### **Whale Tail MDRB Report No 25B**

Report No 25B, Amaruq  
Meadowbank Mine Dike Review Board  
Meetings September 9-11 and November 27, 2019

Photo No. 3 East sector of Whale Tail Dike

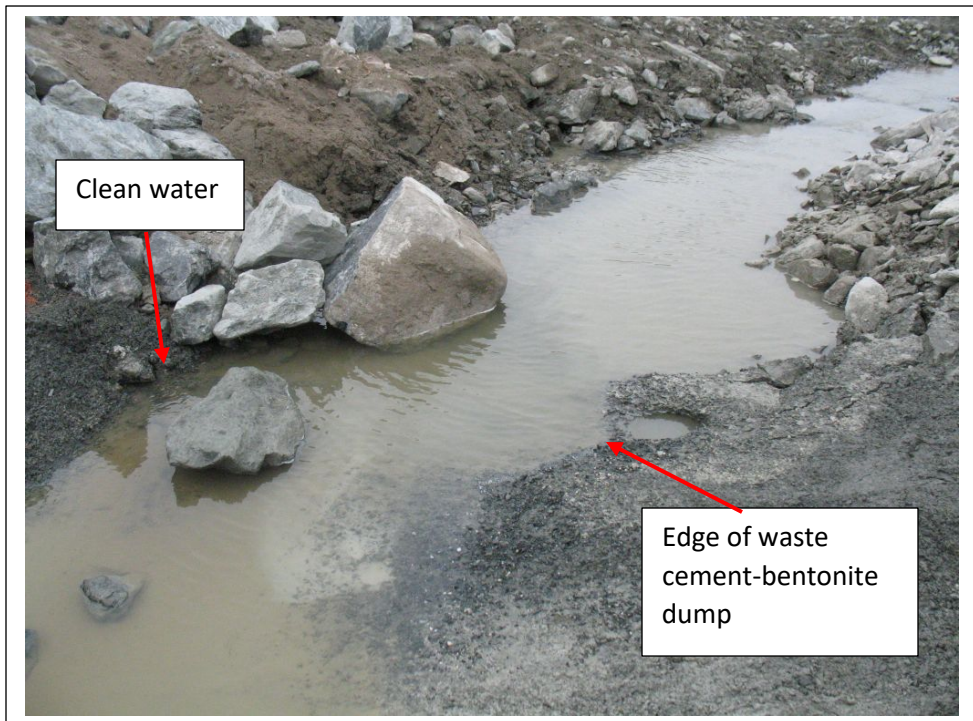
Seepage has been observed since the creation of this hydraulic gradient. Turbid water was noted near the east abutment soon after the start of drawdown whereas water discharged at the downstream toe near the dam centre from Stn. 0+670 towards the west abutment is clear (Photo no. 3). Examination of the area near the east abutment shown in photo no. 4 shows clear water discharging at the toe of the dam and sediment laden water from the waste dump side. It appears that this dump, used for the disposal of cement-bentonite waste during construction, is the probable source of sediment in the discharge water. Although much of this material has subsequently been removed, disturbance due to excavation activities has released additional sediment. The flow of the turbidity laden water is captured separately (photo no. 5) and measured at the V-Notch weir shown in photo no. 6.

Photo No. 13 South Whale Tail Pond in vicinity of east abutment

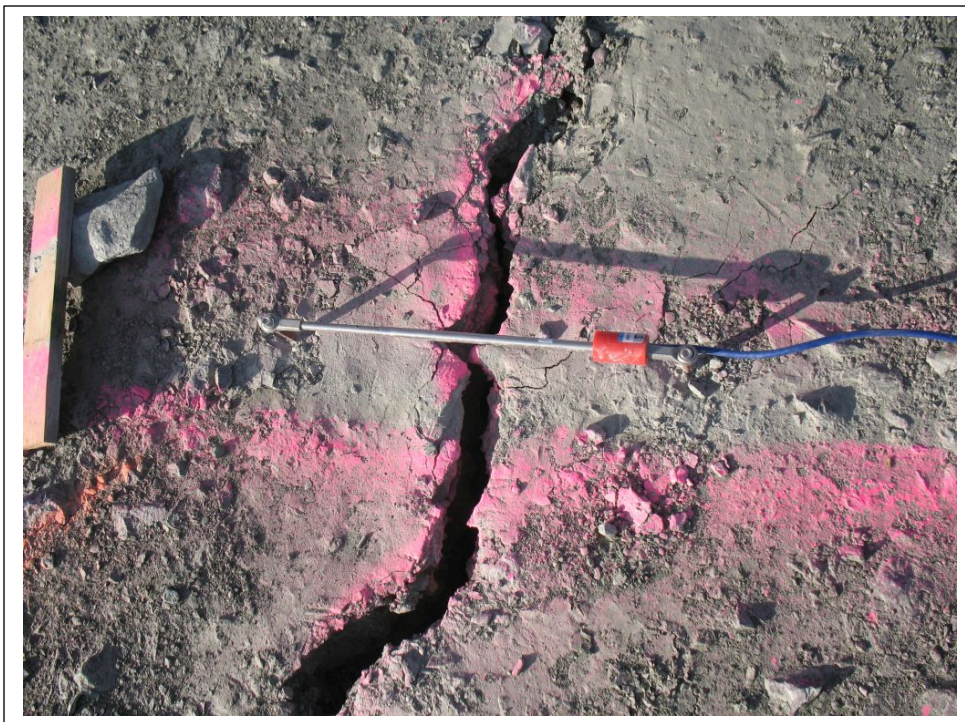
The Board also sees merit in enhancing the potential for freeze back to contribute to seepage reduction. Areas such as the submerged upstream east abutment, shown in photo no. 13, could

be covered with low permeability, well graded granular fill (esker sand and gravel rather than rockfill) to minimize water heat flux and augment the surface area exposed to cold air temperatures in the upcoming winter season. A similar approach is suggested for the downstream side of the dike, both at the abutment and on the lakebed.

The Board wishes to reiterate its recommendation to add granular material or fine rockfill in the area at the east abutment on the upstream side where excavations have exposed the foundation to the water of the south Whale Tail lake. The fill should be placed to an elevation above the maximum estimated full head in the lake such that the fill surface is exposed to winter conditions that will encourage re-establishment of permafrost.

Photo No. 18 Seepage flow from NE Dike

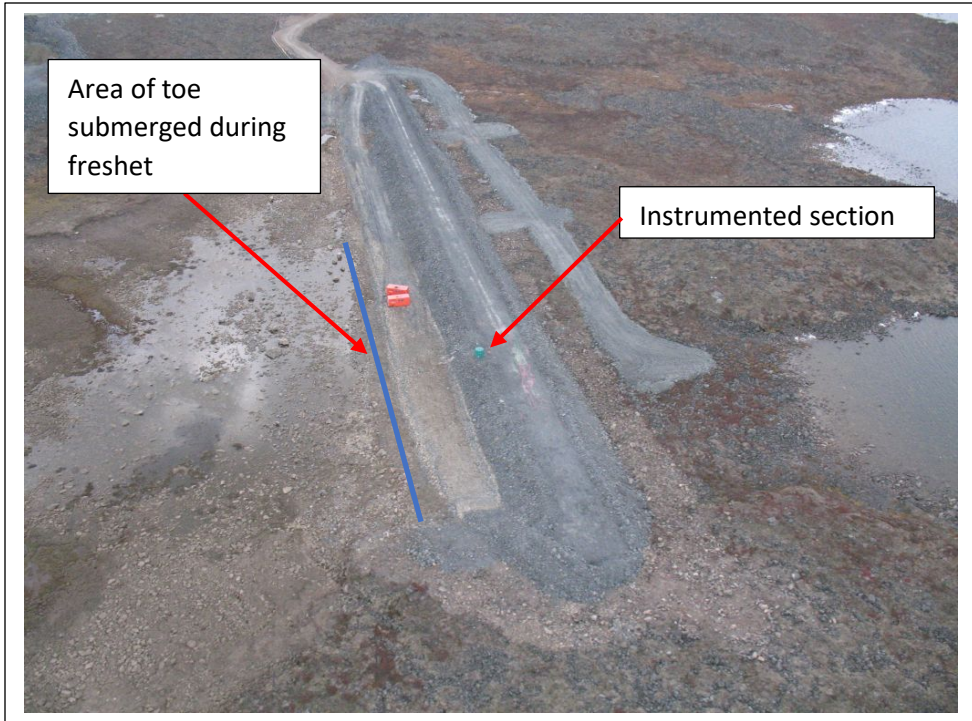
no. 16. Photos nos.17 and 18 show the flow pipe currently monitoring the ongoing seepage. There are no other instruments in this structure and therefore, the permafrost condition of the foundation cannot be verified. However, the presence of flow indicates the potential for permafrost degradation. This dike will have a short life-span (intent 2 years) and monitoring, together with enhanced pumping capacity for the 2020 freshet, may suffice. No additional information provided at the November meeting changes this view.

Figure 1 Cross-section of Whale Tail Dike at Stn. 0+700 showing potential seepage pathways

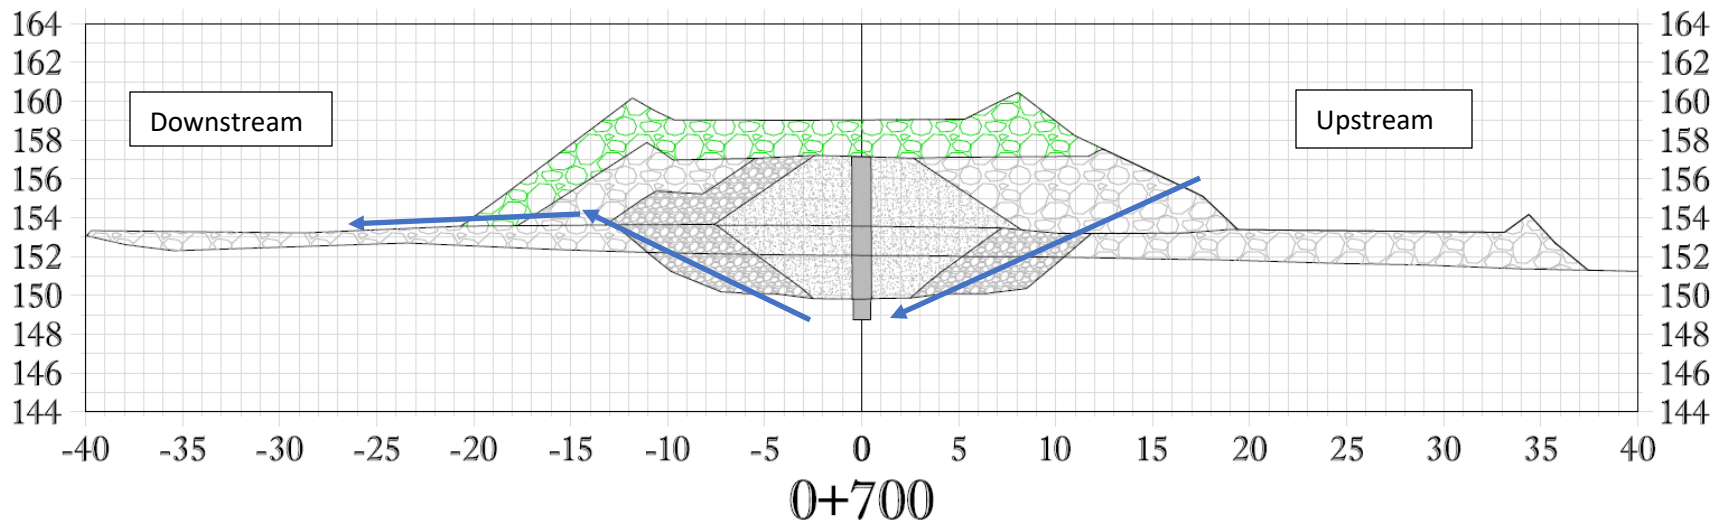
The abutments and much of the eastern side of the lakebed (shallow water) were in a permafrost condition. The Board had previously cautioned that the foundation rock in a permafrost condition is not amenable to grouting and, indeed, none was attempted beyond Stn. 0+516. A section through the dike is shown in figure 1. Ice rich overburden was excavated in the central portion down to bedrock and was replaced by fine and coarse filter material prior to the construction of the cut-off wall. The presence of "warm" lake water, particularly with the raising of the south basin, has initiated thaw of the ice in rock discontinuities which developed into a continuous process whereby seepage flow and the attendant heat flux led to an extension of the area of thawed foundation rock through which flow can take place.

The cracks that have been observed on the dike crest (Photo no. 14) are also believed to be the result of thaw settlement in the overburden which remained below the upstream and downstream shells (see figure 1). Deformation of the dike has been noted in the results of the inclinometer measurements. This is likely also related to thaw settlement under the shells and to the application on the cut-off wall of hydrostatic thrust. The addition of a few survey monuments would permit monitoring of future movement on the outer edges of the crest.
